TECHNICAL BULLETIN

New 6" AdvanceDrive Wheels

SUBJECT: New 6" aluminum AdvanceDrive wheels

Figures 1 and 2 (below) show the differences between old and new AdvancedDrive wheel assemblies.

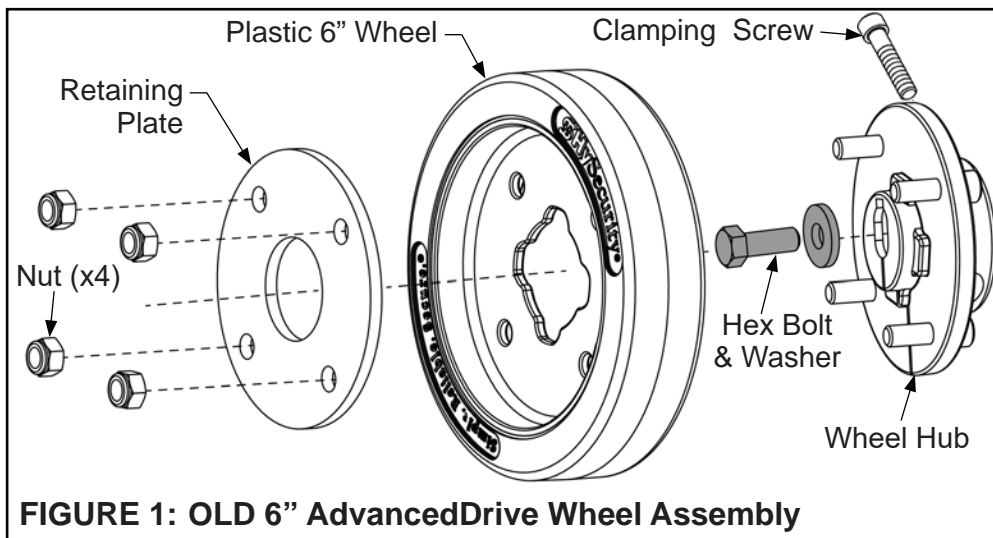
The 6" AdvanceDrive wheels used in SlideDriver models have been replaced with new wheels that do not require a metal retaining plate. The 8" AdvancedDrive and 8" XtremeDrive wheels used in some models will be updated similarly at a later date.

Simpler disassembly during maintenance.

NOTE: New wheels are compatible with the hubs from plastic wheels but require new nuts. If replacing older aluminum wheels they will need a kit with a new hub.
